The Purpose of this Addendum is to new information regarding the Fire Alarm Scope

**Addendum**

<b>Project</b>	DISD Harry Stone Montessori Academy	<b>Addendum Number</b>	01
<b>Project Number</b>	R22301	<b>Date</b>	02/25/2026
<b>To</b>	Gary Mirak

DRAWING TITLE:  
**OVERALL LEVEL 01 - FIRE ALARM PLAN**

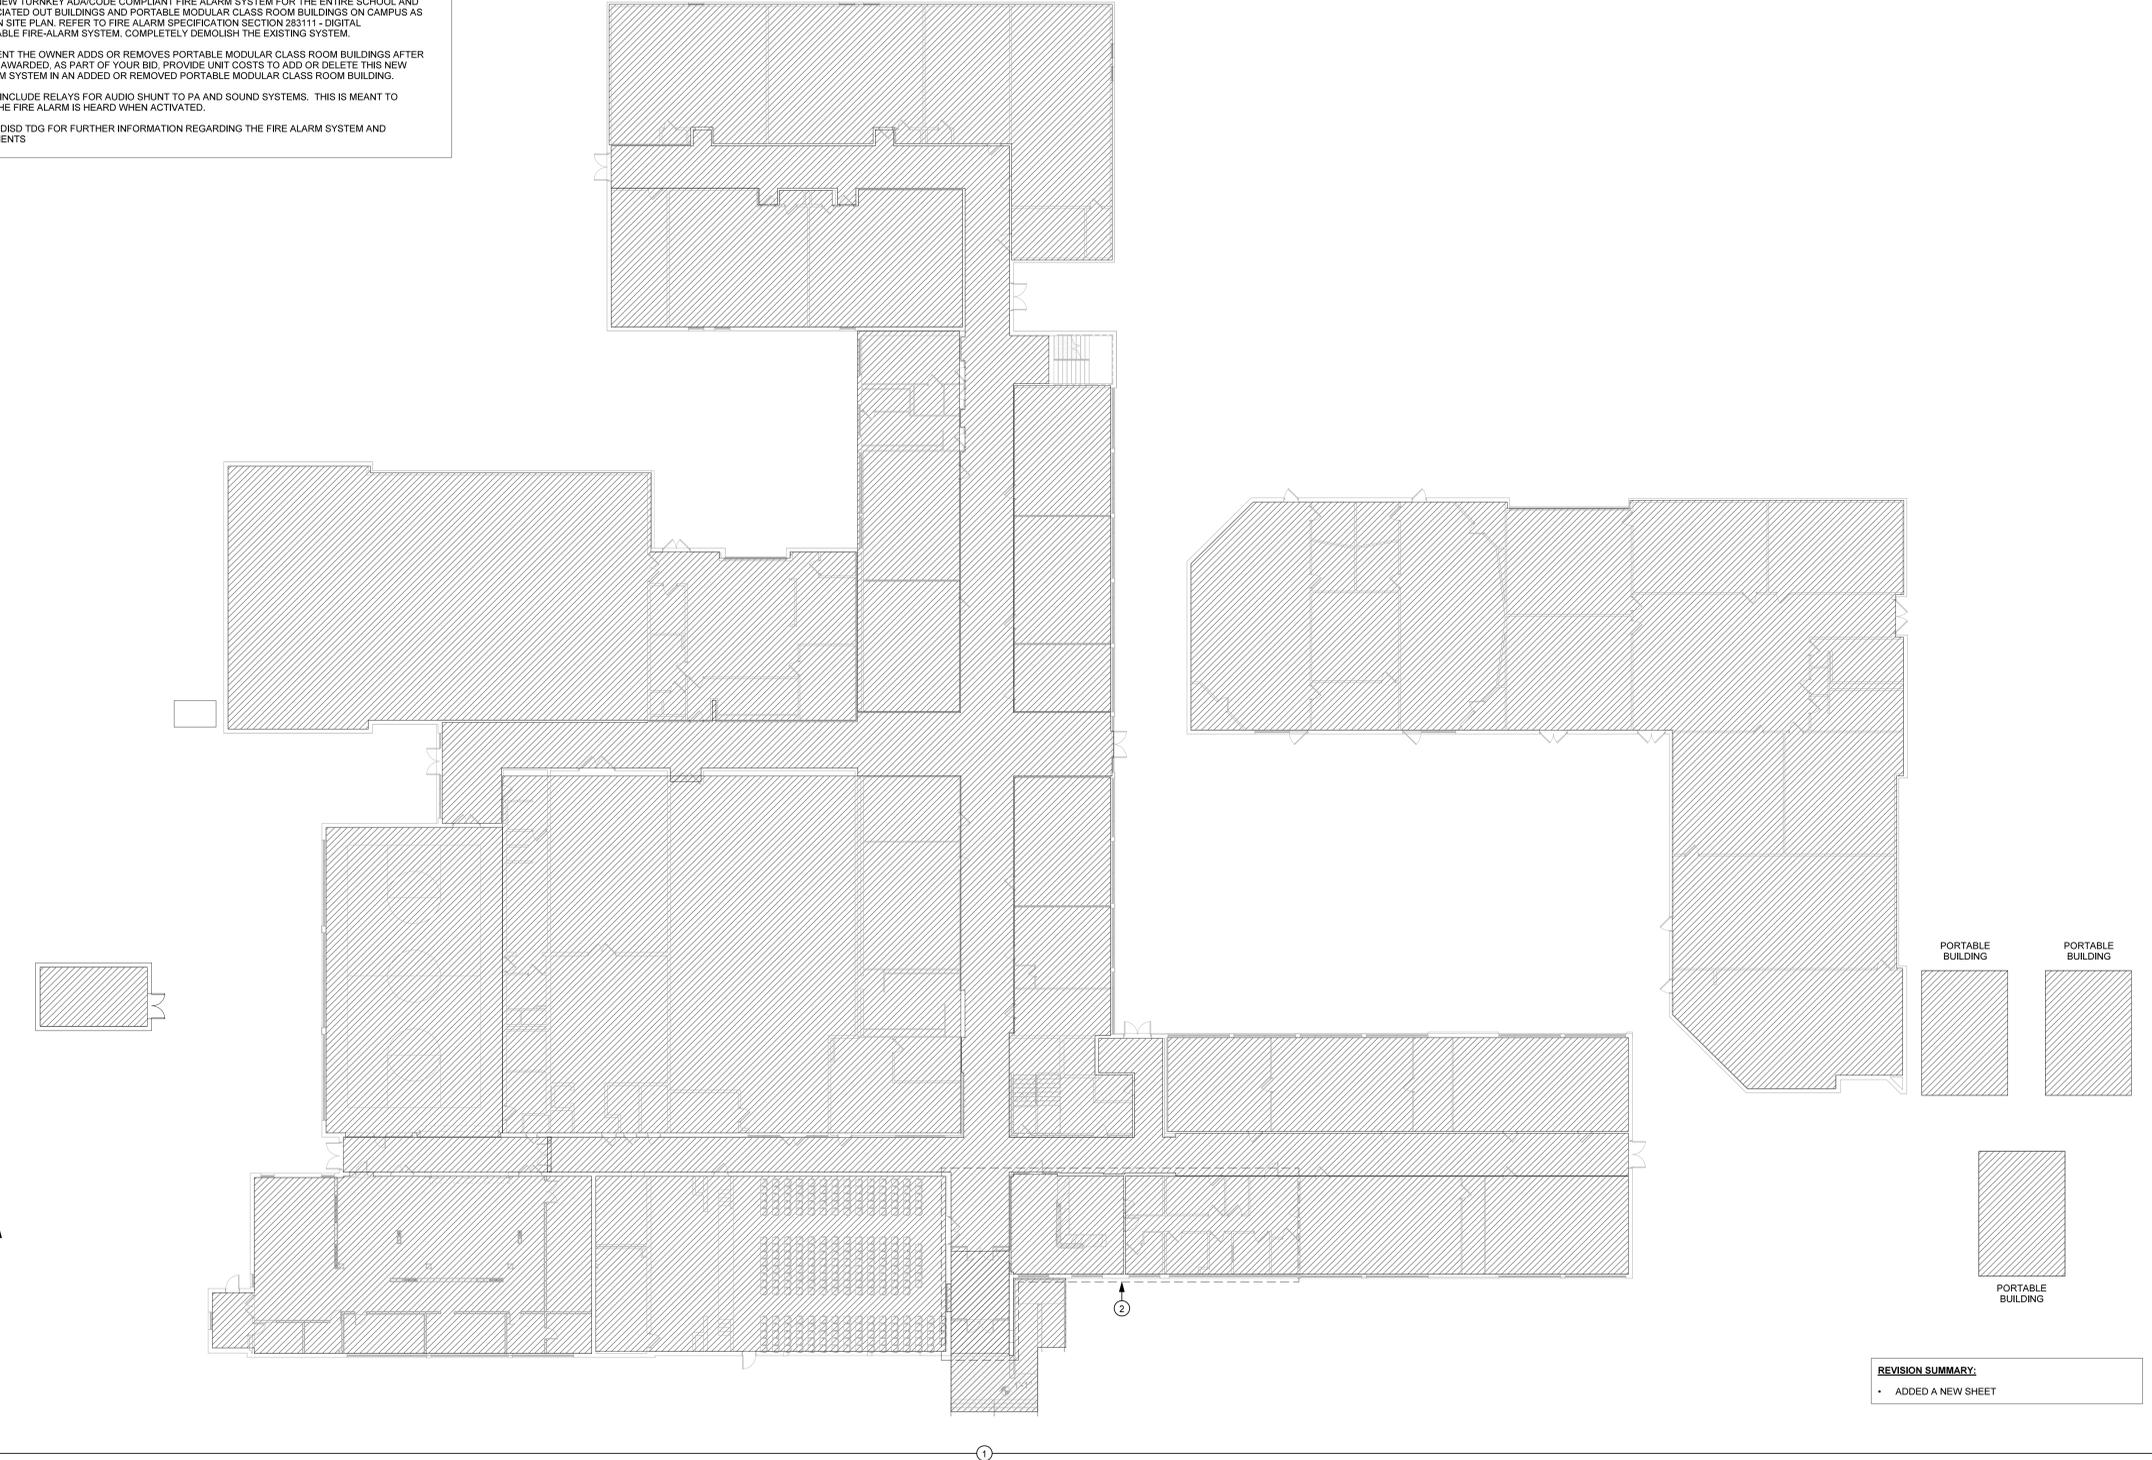
- FA101 - OVERALL LEVEL 01 - FIRE ALARM PLAN**
  - A new sheet was added to the document package per DISD requirement
  - Added the Fire Alarm General Notes to the sheet
  - Indicated across the entire scope of work that all the fire alarm components are to be removed and a new fire alarm system shall be installed
  - Noted the approximate area that the fire alarm annunciator panel and the fire alarm control panel is located
  - Added portable buildings to the fire alarm overall plan

- 1 DEMOLISH THE EXISTING FIRE ALARM SYSTEM AND PROVIDE AND INSTALL A NEW FIRE ALARM SYSTEM.
- 2 EXISTING FACP AND FAAP ARE EXPECTED TO BE WITHIN THE VESTIBULE AND ADMIN SUITE. CONTRACTOR SHALL FIELD VERIFY THE EXISTING LOCATIONS AND DEMOLISH THESE ITEMS.

DRAWING TITLE:  
**OVERALL LEVEL 02 - FIRE ALARM PLAN**

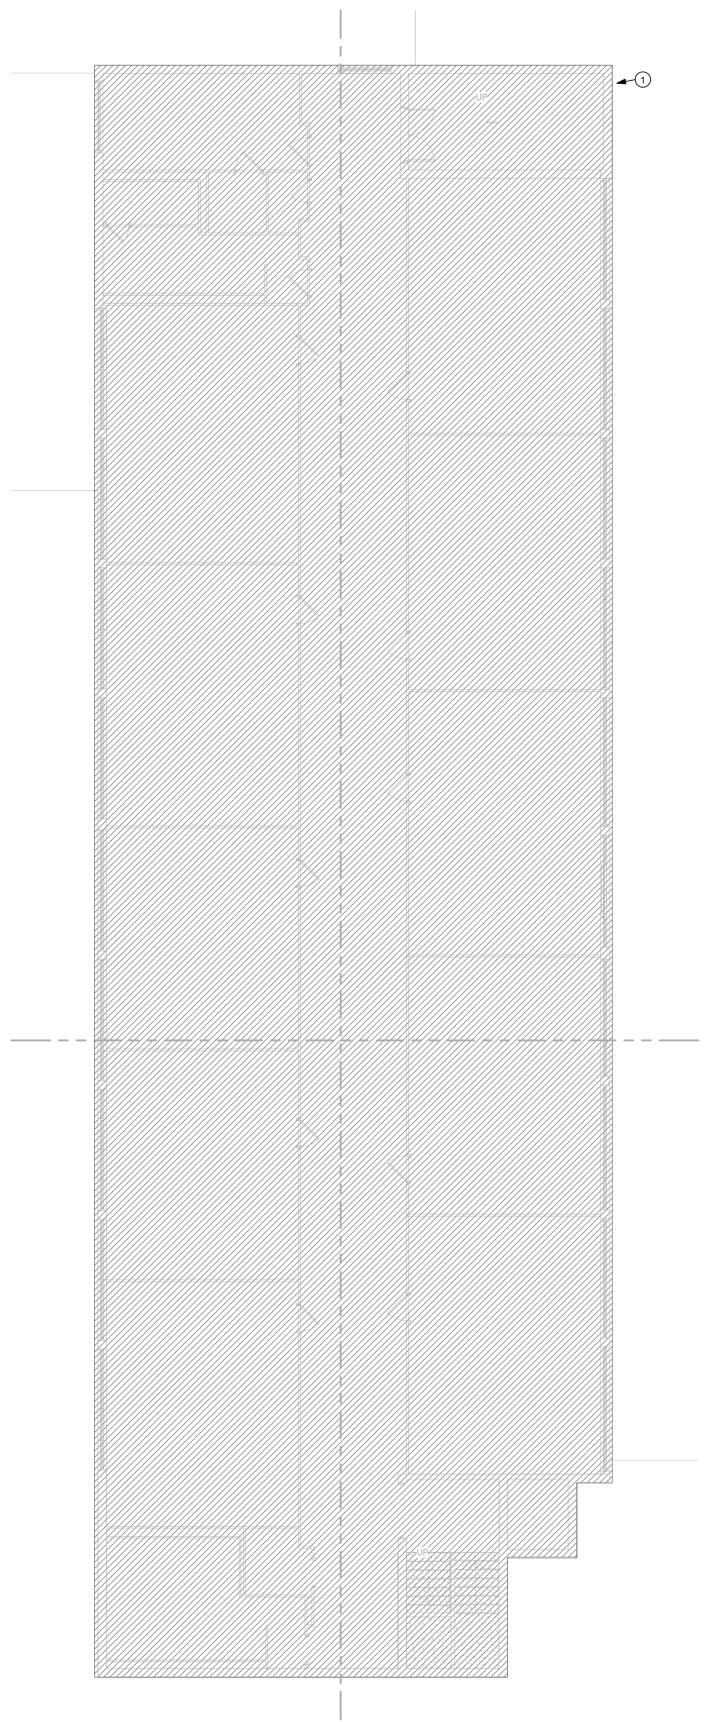
- FA102 - OVERALL LEVEL 01 - FIRE ALARM PLAN**
  - A new sheet was added to the document package per DISD requirement
  - Indicated across the entire scope of work that all the fire alarm components are to be removed and a new fire alarm system shall be installed

- 1 DEMOLISH THE EXISTING FIRE ALARM SYSTEM AND PROVIDE AND INSTALL A NEW FIRE ALARM SYSTEM.
- 2 EXISTING FACP AND FAAP ARE EXPECTED TO BE WITHIN THE VESTIBULE AND ADMIN SUITE. CONTRACTOR SHALL FIELD VERIFY THE EXISTING LOCATIONS AND DEMOLISH THESE ITEMS.
